REMARKS

I. Status of the Application

FIG. 1

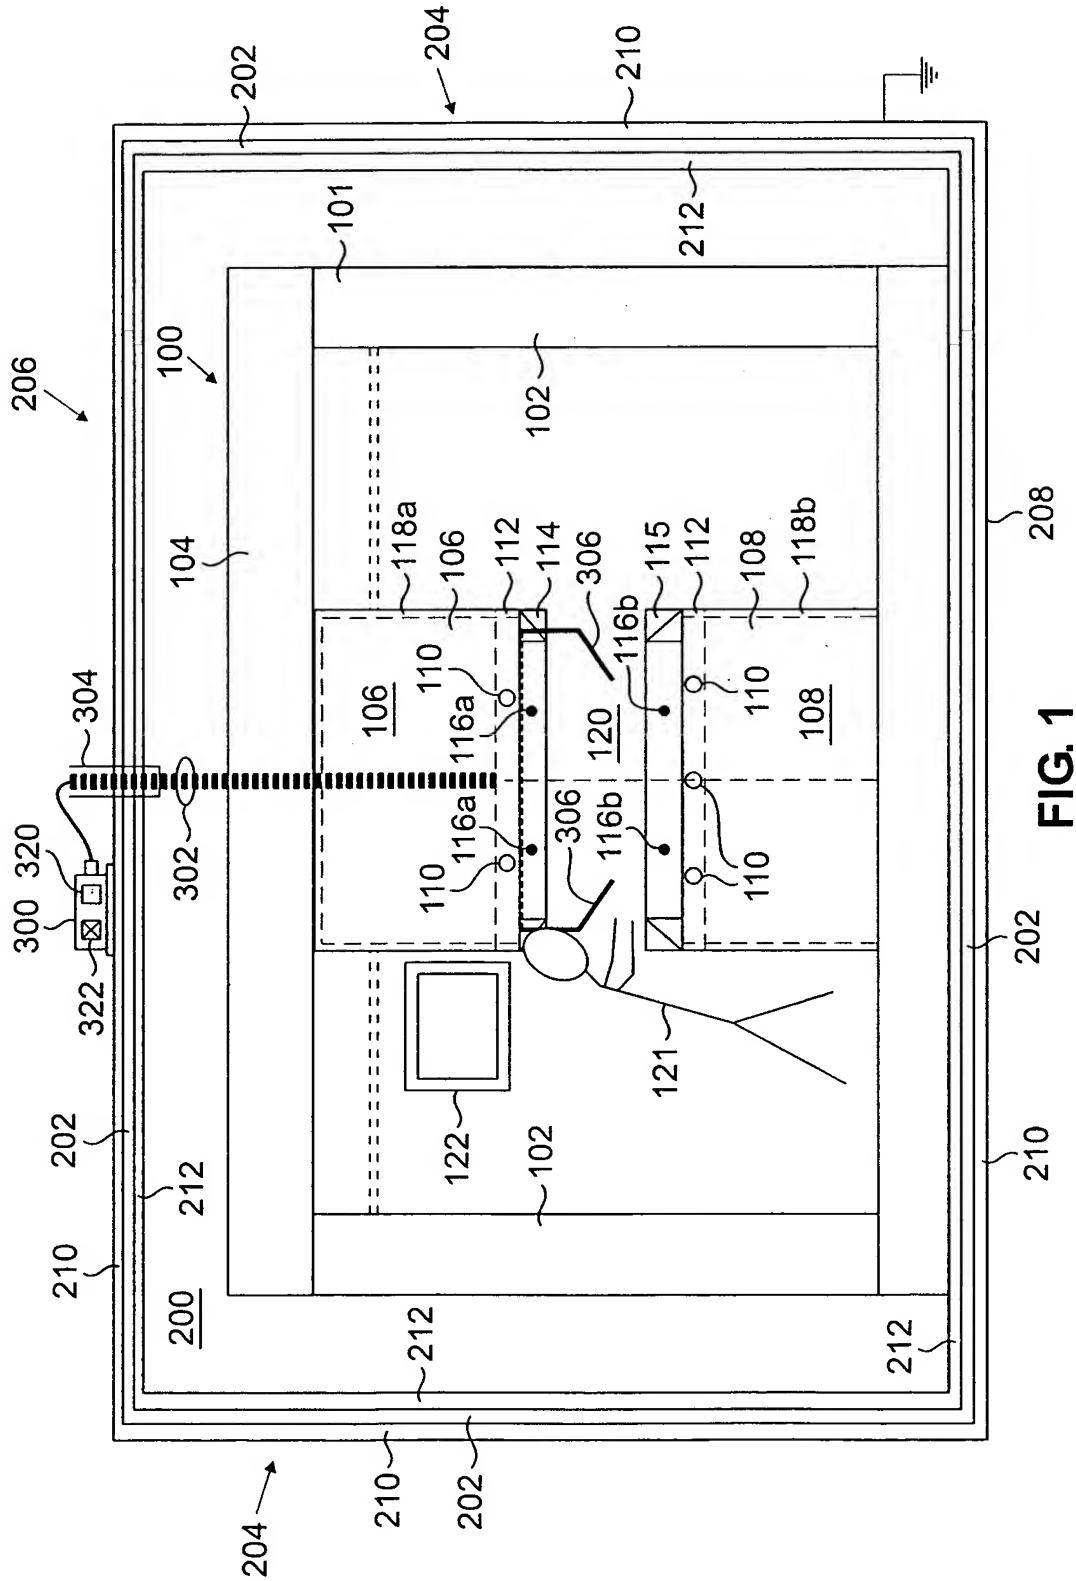
The drawings have been objected to as allegedly failing to comply with 37 CFR § 1.84(p)(5), because they allegedly do not contain reference numbers 101, 106a, 114, 116, 118a, 118b, 124, 320, and 322.

Reference numerals 114 and 124 are shown in original Fig. 1 and in Fig. 2, respectively. The paragraph starting on page 6, line 14 is amended to delete reference to Fig. 1, since item 124 is only shown in Fig. 2.

In Fig. 1, numeral 101 is inserted in Fig. 1, numeral 118 is changed to 118a or 118b, and a bulb 320 and a fan 322 are added, as described on page 8, lines 5-9. In Fig. 2, numeral 116b is changed to 116a and numeral 118 is changed to 118a. In Fig. 3, numerals 106a and 118a are inserted. The paragraphs starting on page 5, line 4 and on page 5, line 22 are amended to delete references to numeral 116. The Examiner is thanked for pointing out these omissions.

Replacement drawings for the original drawings are enclosed, along with a marked up set of drawings showing the changed and added numerals, as well as the bulb 320 and the fan 322, highlighted in yellow. No new matter has been added.
